REMARKS

Claims 1 - 3 remain active in this application. New claims 4 and 5 have been added. The specification has been reviewed and editorial revisions made where seen to be appropriate. Claims 1 and 3 have been amended. Support for the amendments of the claims and new claims 4 and 5 is found throughout the application, particularly in Figures 1 and 2 and the description thereof on pages 4 - 6, especially the paragraph bridging pages 4 and 5. No new matter has been introduced into the application. The acknowledgment of the claim for priority and receipt of the priority document is noted with appreciation, as is the consideration of the documents cited in the Information Disclosure statement filed December 19, 2003.

FIG. 1

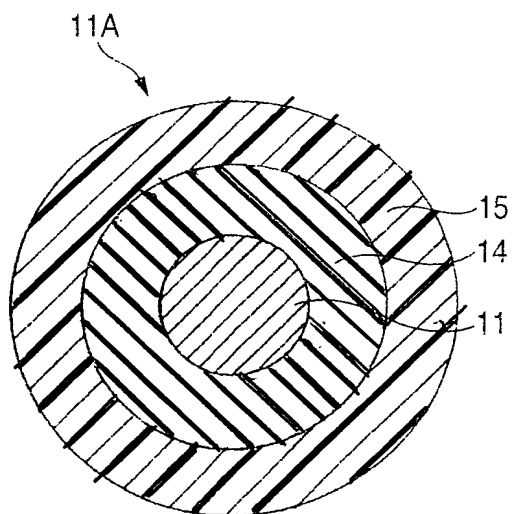
The Examiner has objected to the drawings in regard to cross-hatching in Figure 2 and labeling of Figures 3 and 4. This objection is respectfully traversed as being moot in view of the revisions of the drawings proposed above.

Proposed revisions in the drawings are shown in red in the attached sheets and replacement drawing sheets are being concurrently filed herewith. Revised cross-hatching has been proposed in Figures 1 and 2 to indicate insulation and resin with ferrite compound therein which are believed to be in accord with M.P.E.P. §608.02 and the label "Related Art" has been proposed in Figures 3 and 4 to correspond to terminology in the Brief Description of the Drawings. Accordingly reconsideration and withdrawal of this objection is respectfully requested.

Please approve the proposed drawing revisions as shown in the attached sheets. Replacement sheets of drawings are also concurrently filed herewith.
